ARCHITECTURAL DESIGN REPORT  
ADDENDUM

# POWERHOUSE PARRAMATTA

8 OCTOBER 2020

Setbacks Diagram

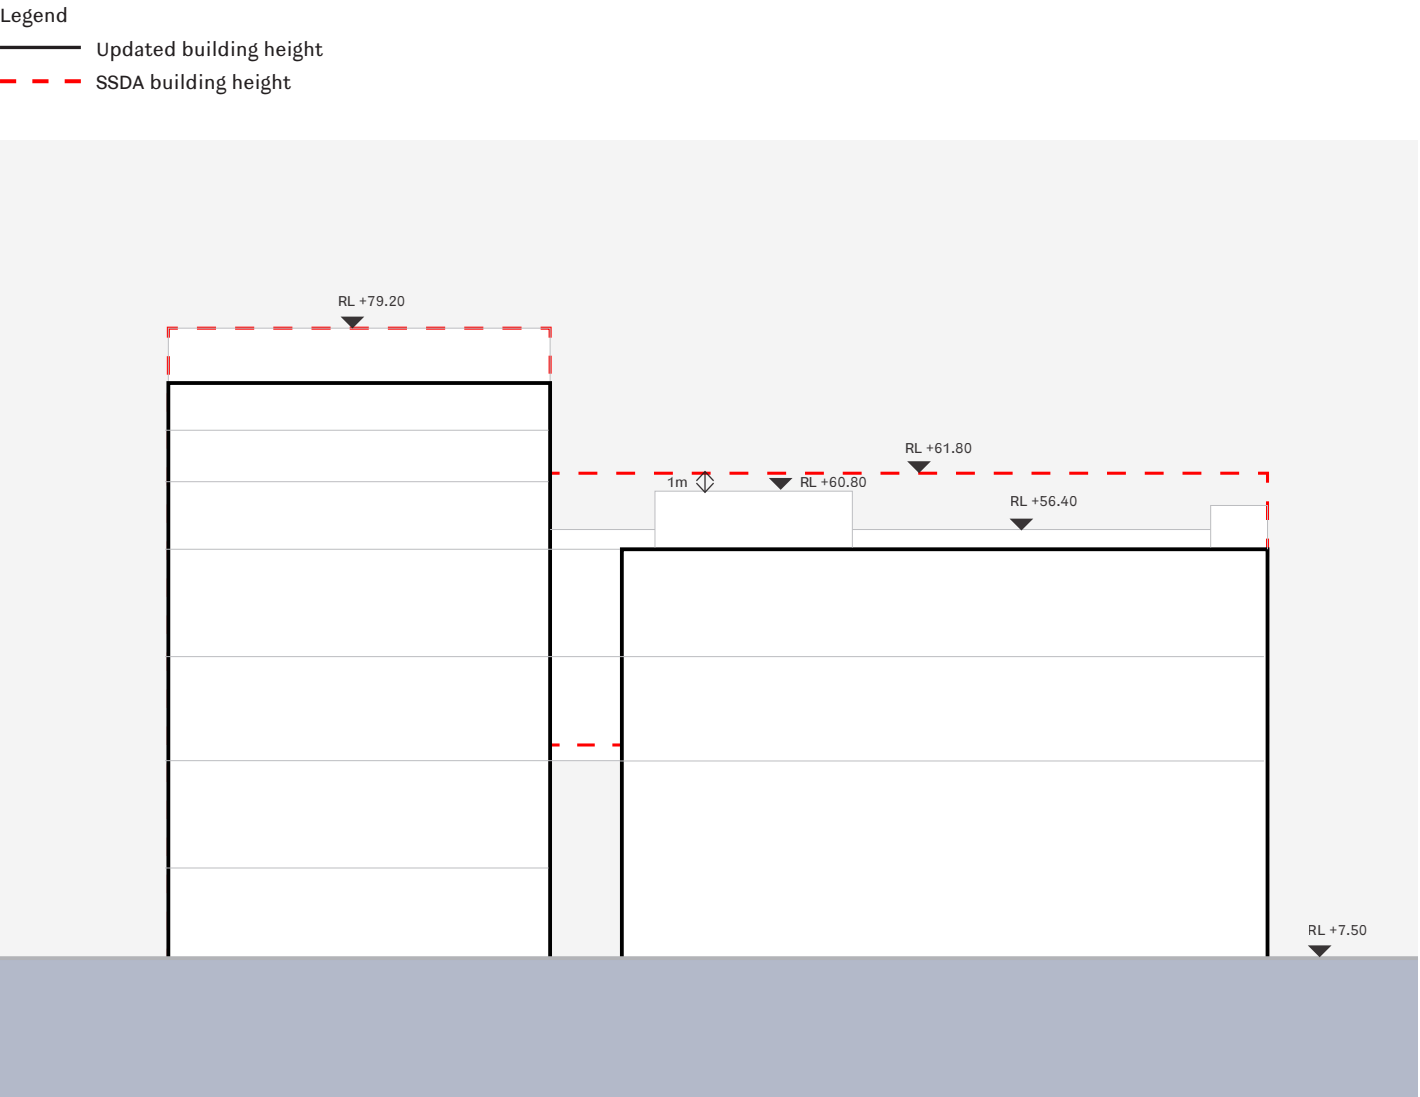
Key building setbacks have been increased in order to respond to submissions pertaining to the building’s relationship with the Parramatta River, Phillip Street and the general public domain.

The setback from the river has been increased to 28.3m, which exceeds the minimum requirement outlined by the DCP and the Civic Link DCP. This provides a more generously scaled public domain north of the building enabling a more appropriate and respectful relationship with the waterfront.

The setback from Phillip Street has increased to 13.2m, which provides increased curtilage and generosity between Powerhouse Parramatta and the city. The additional setback creates more space to facilitate a multifunctional public domain at street level and facilitates the bus drop off location.

The Wilde Avenue setback has been maintained and continues to be driven by the spatial requirements of the structural foundations supporting the exoskeleton, in ground services and the site boundary.

The setback on Dirrabarri Lane continues to be defined by the Right of Carriageway providing service access to the neighbouring property to the west of the subject site.

As a result of the above approach which favours the public domain outcome, the setback to the GE building south of the western building has decreased by 1.15m from 10.4m to 9.25m.

Updated Design - Public Domain Section

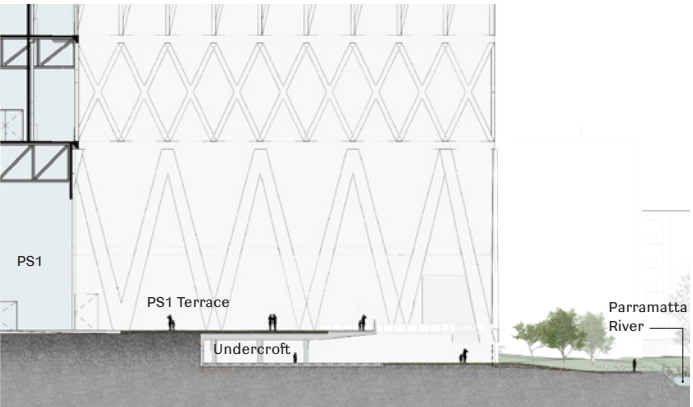
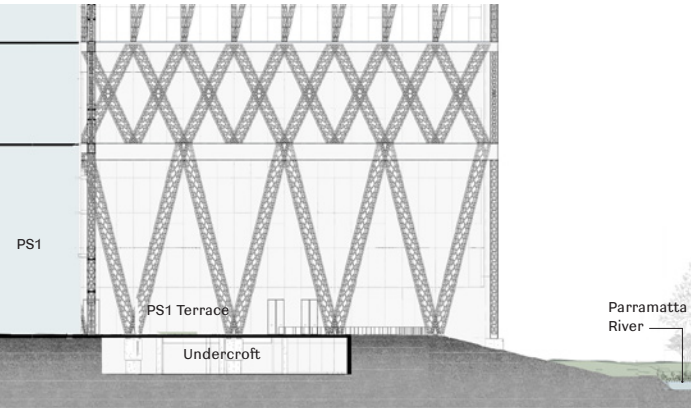
The public domain between the building and the river has been reconfigured to better align with the principles of the original competition scheme. This includes the incorporation of a sloped embankment that seamlessly bridges the level difference between the riverfront promenade and the PS1 terrace which allows the Civic Link to extend northward and connect directly with the river front.

The river front lawn north of the western building sleeves under the ground floor of the western building in line with the competition scheme and acts as an extension of the waterfront public domain, providing shelter to support its activities whilst satisfying the flood requirements of the site.

The competition scheme provided an accessible path of travel connecting the podium level with the river level, however this was in conflict with the requirement for a programmable external space level with PS1. The current design connects the two levels via a generous and realigned public stair positioned at the northern end of the Civic Link and a public lift, both of which are available for use 24/7. These work alongside pedestrian paths situated along the western and eastern boundaries to provide a network of connections between the two levels.

Exoskeleton

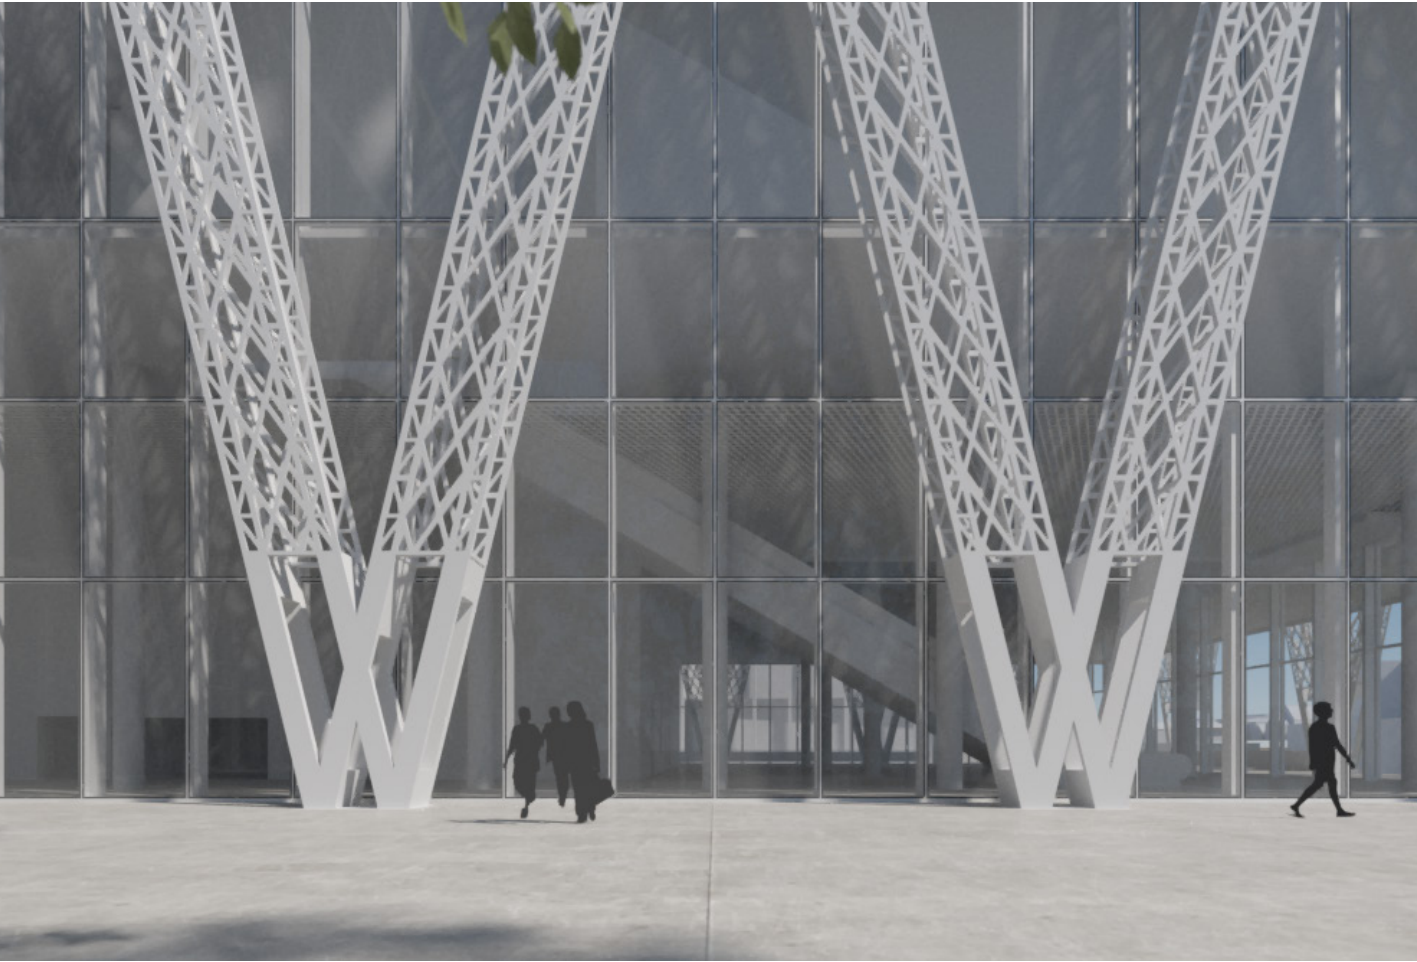
The configuration of the exoskeleton super structure has been amended along the north facade of both buildings to improve its public domain interface and overall structural performance.

Along the western building, the exoskeleton now extends below the level of the retail terrace to engage the river level, clarifying the structural diagram and its public domain interface in line with the original competition scheme.

Along the eastern building, the exoskeleton continues along the northern facade in front of PS1, resulting in an optimal structural solution and reinforcing the uniformity and therefore massing of the overall building.

The detail design of the exoskeleton has been progressed and refined through ongoing design development and in response to constructability and engineering requirements. It has resulted in a more refined latticework pattern, uniformly applied to the entire exoskeleton except for the point at which it engages the ground plane. Here, the climbability risk was addressed by stopping the latticework 4m above the ground plane and adopting a more solid language of fabricated steel sections.

North Elevation

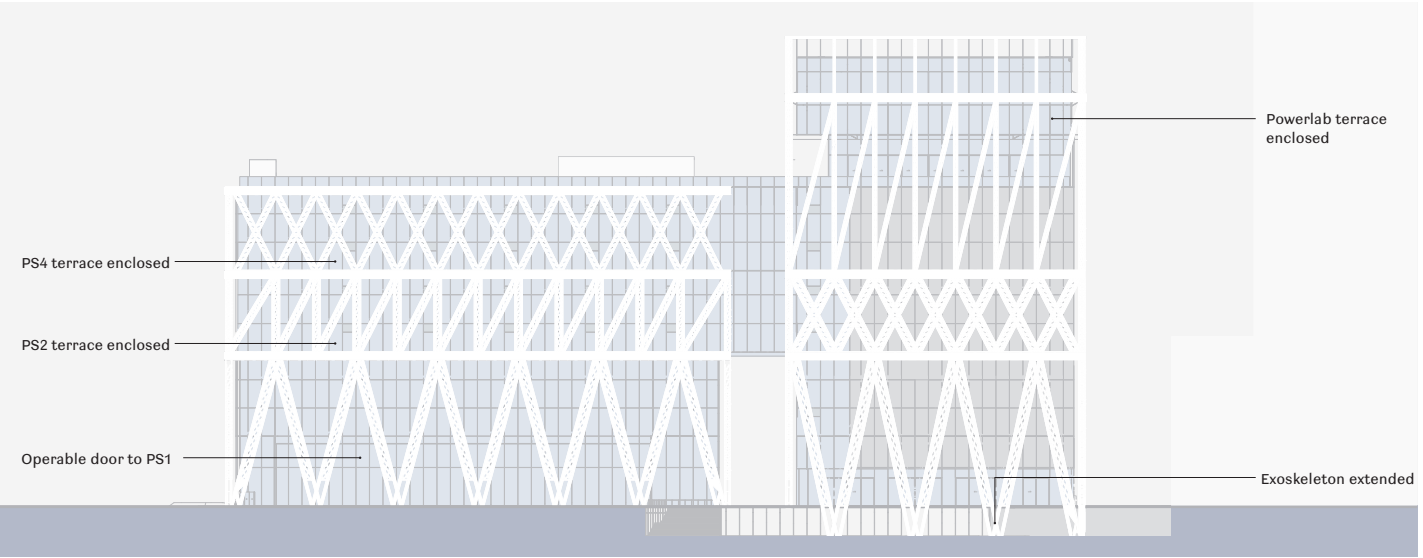
The height of the large operable door to PS1 has been reduced from 20m to 9.25m. In order to improve the operational usage of this door, it has been changed from a sliding door to a guillotine door. The portion of facade immediately above the door continues to be transparent.

The external terraces on the northern side of PS2 and PS4 were enclosed to create more appropriately scaled circulation zone internally.

The Powerlab terrace on Level 5 of the western building has been reclaimed as internal floor area as part of optimisations to the internal planning of the functional areas. The terrace to PS7 is retained and will continue to

South Elevation

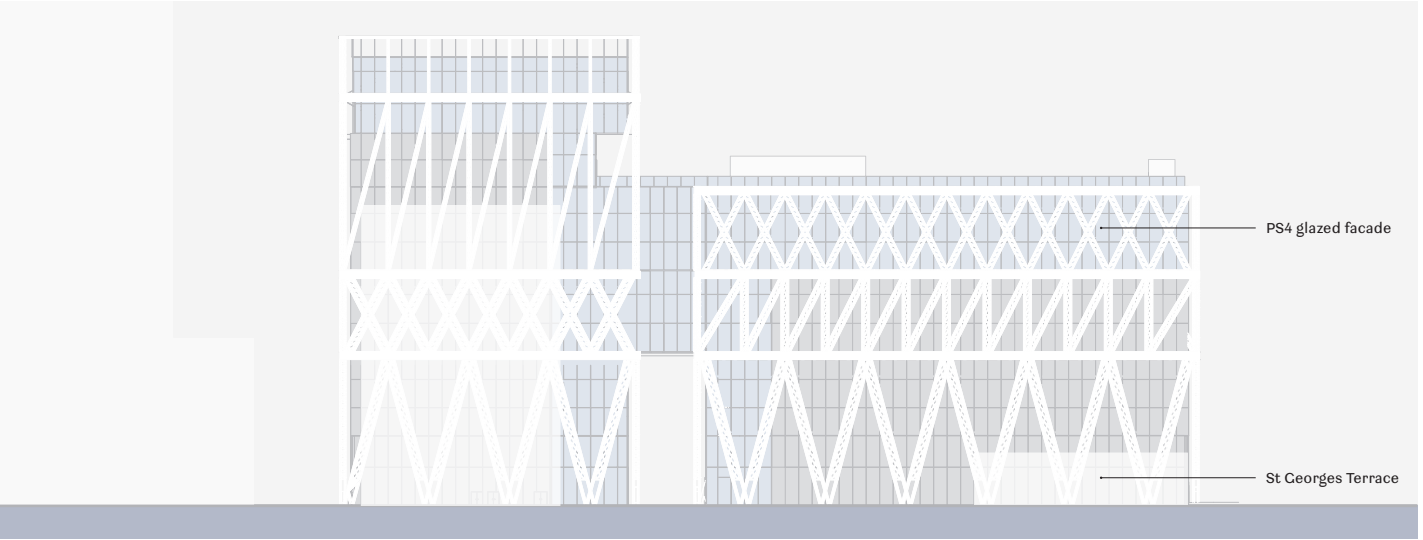
The ground level glazing and fire doors to Presentation Space 1 along the Phillip Street facade of the eastern building has been removed to meet the performance requirements of PS1.

The topmost presentation space within the eastern building has been opened to the city via full height glazing along the south facade.

In addition to the above changes, the panelisation for the glazed and opaque walls has been optimised to 2m to improve constructibility.

Functional Diagram

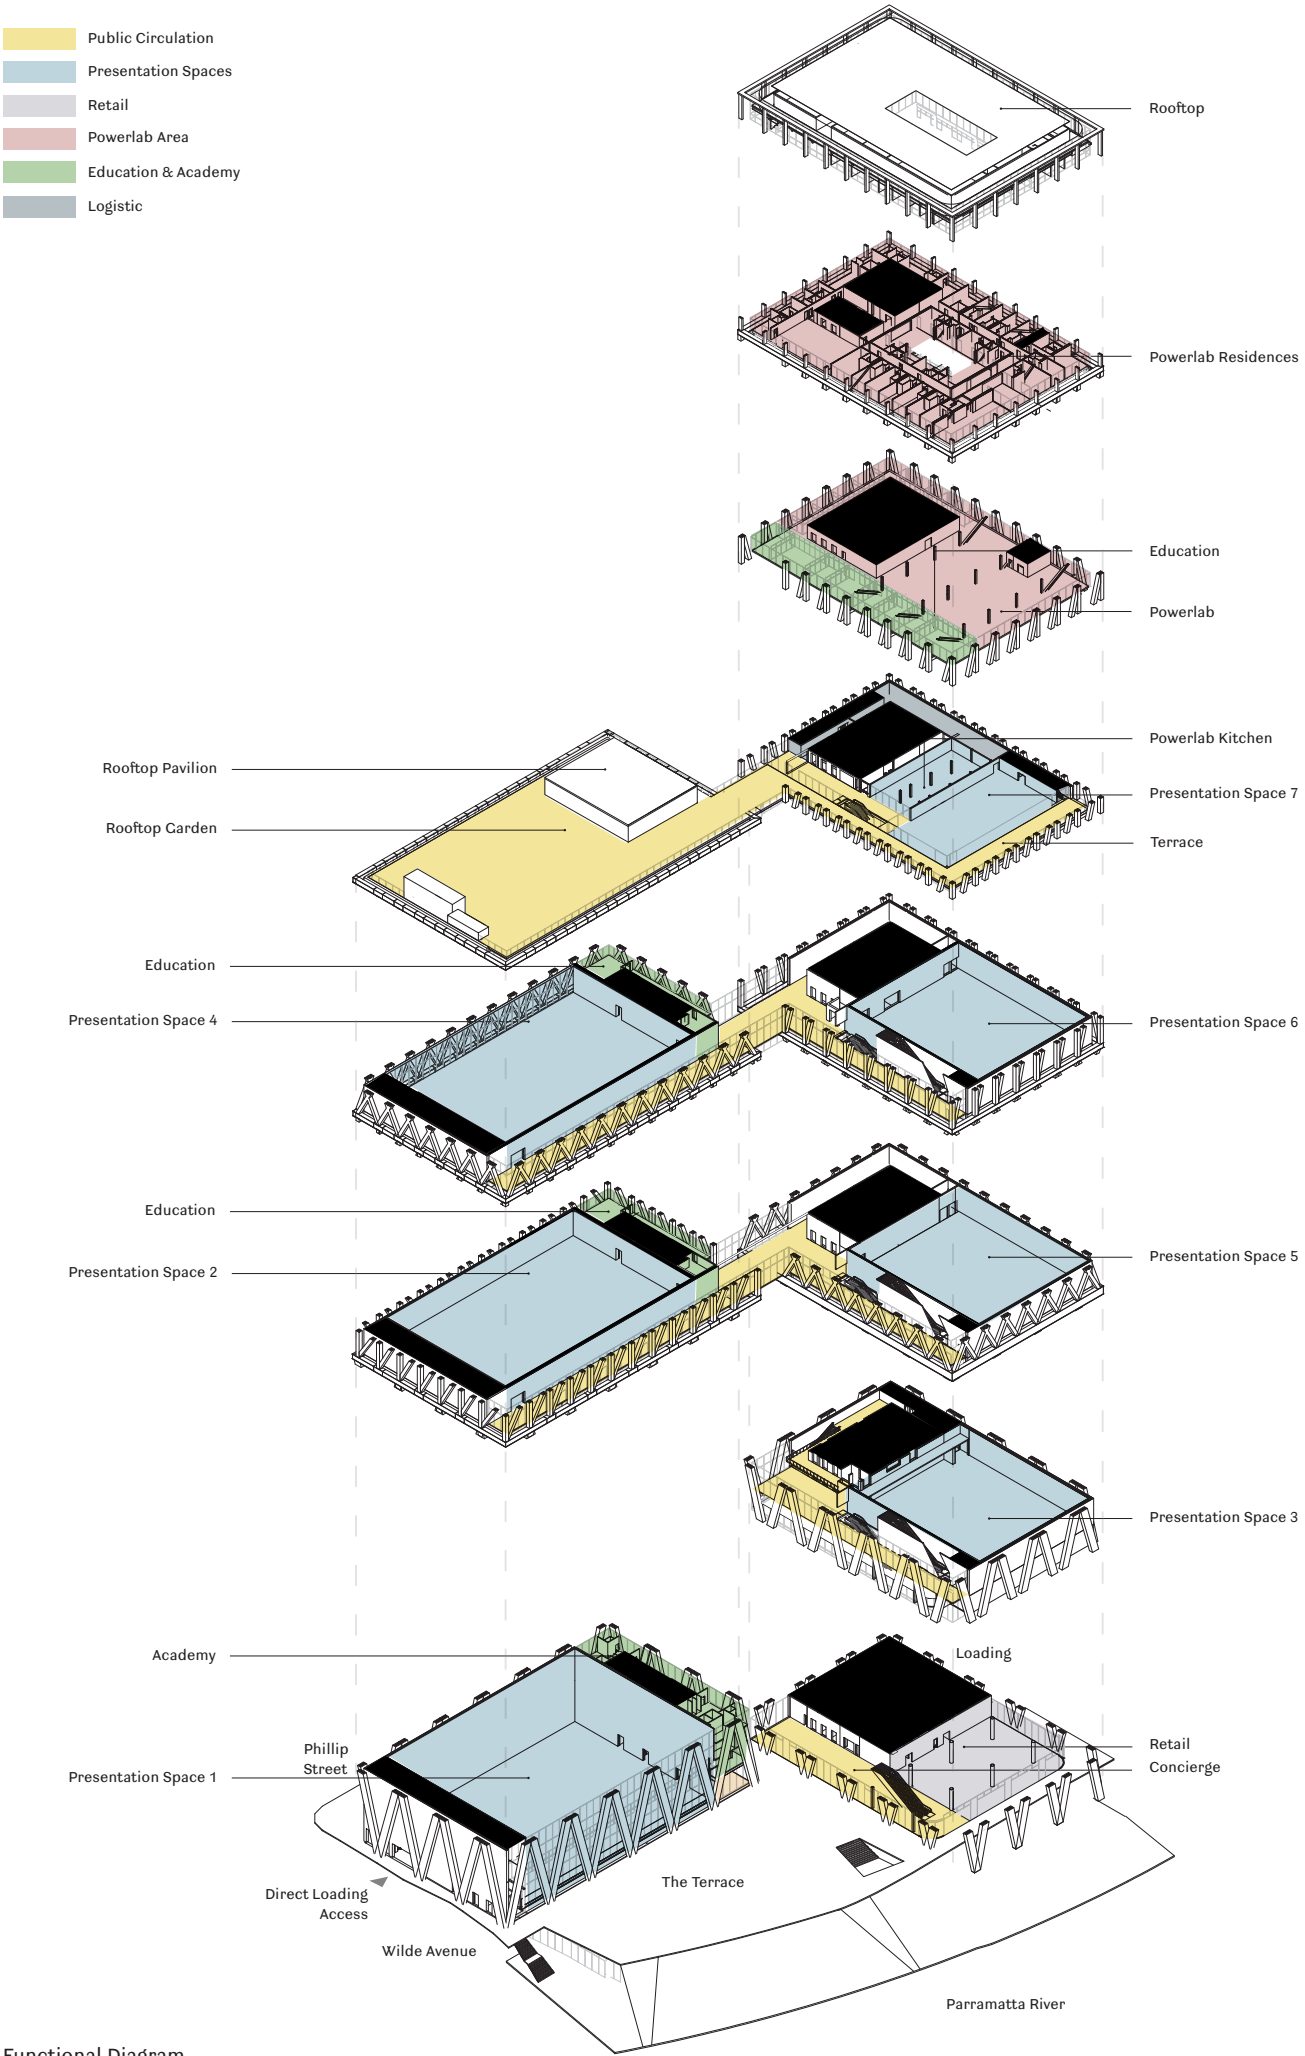
A portion of the street level retail along the western facade of the eastern building has been removed following further coordination of egress paths, services and public circulation.

To compensate for this reduction, a rooftop pavilion has been added to the eastern building, providing a multifunctional protected indoor/outdoor space with high visual amenity. This space will be used for education, community and event activity.

A significant portion of the education spaces have been relocated from the eastern building to the Powerlab on Level 5 of the western building. This enabled the structural design of the eastern building to be further optimised whilst also allowing the proportion of the presentation spaces in the eastern building to improve in line with operational requirements.

The Powerlab Terrace has been removed to create more internal space for the Powerlab Offices.

The Powerlab Residences have reduced from 40 apartments to 30, creating a more operationally efficient and usable area.

Undercroft Space and Flooding

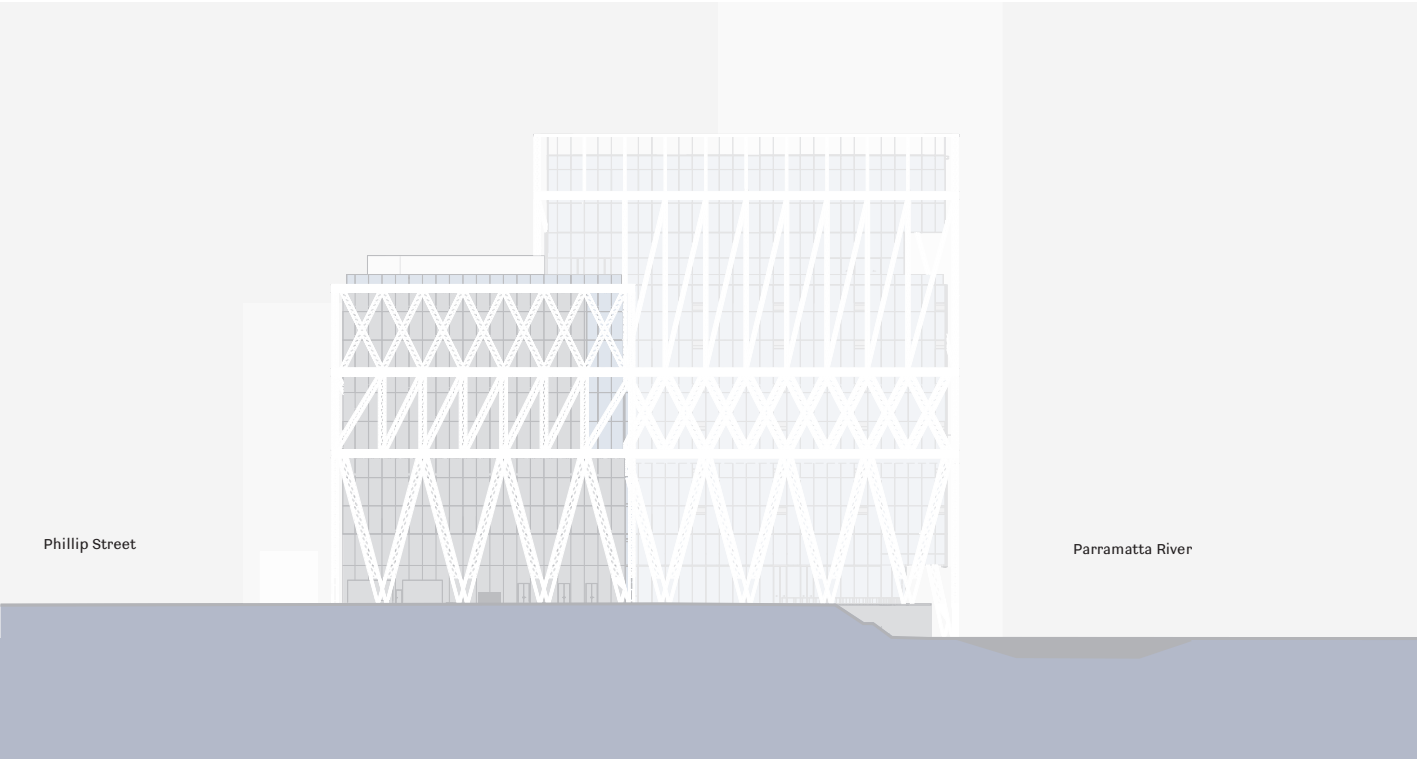
The updated design incorporates two openings situated on the eastern and western sides of the undercroft while the north side is largely concealed by a sloped landscaped terrain in line with the original competition scheme. Portions of the undercroft are screened off by an operable metal mesh which will be open during a flood event.

The undercroft floor and soffit heights are determined by flooding requirements and are nominated to avoid aflux to neighbouring sites along the Parramatta River. The resultant clear heights within the undercroft vary from approximately 3m to 3.5m.

The updated design provides 3 points of evacuation from the undercroft, one along the east, one on the west, and another centered along the northern frontage. The lift which serves the undercroft is included for universal access, not evacuation. It is rated as a flood lift and can withstand exposure to water.
